Development Assessment

Subject: DA2024/0635 - 20 Beatty Street BALGOWLAH HEIGHTS

Record Number: 2024/872552

Figure 1 – Amended first floor plan

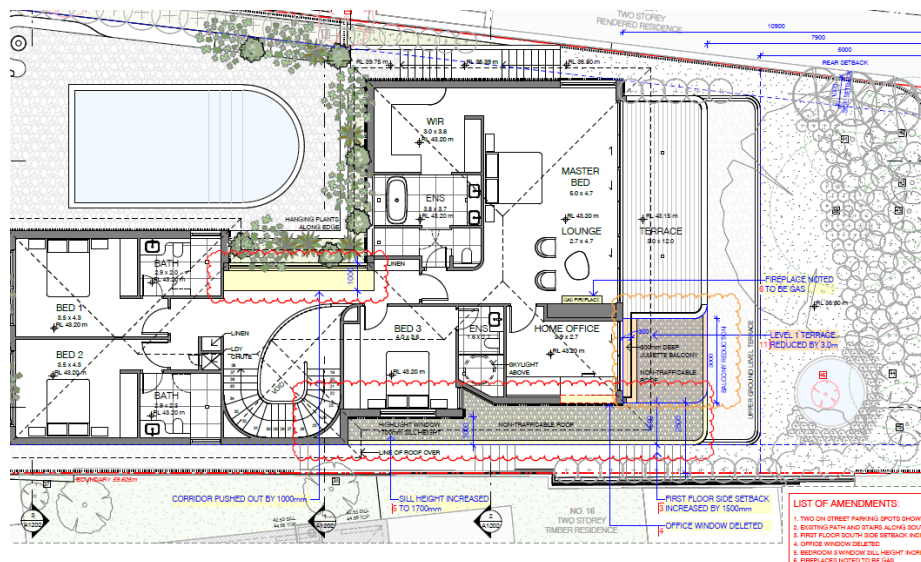
On 28 November 2024, the applicant uploaded an amended set of the architectural plans. The amended plans reduced the size of the first-floor rear terrace by 3.0m. No other changes are proposed.

The proposed amendments will further reduce amenity impacts upon the neighbouring properties, by reducing the useability of the first-floor outdoor living area and increasing physical separation (proposed 5.5m setback) between the subject site and adjoining properties. Therefore, the proposed amendments are supported.

The proposed amendments will have a reduced environmental impact on the adjoining properties and public open space than the original proposal. The amended plans result in a reduced sized development. Therefore, re-notification was not required in accordance with Northern Beaches Community Participation Plan.
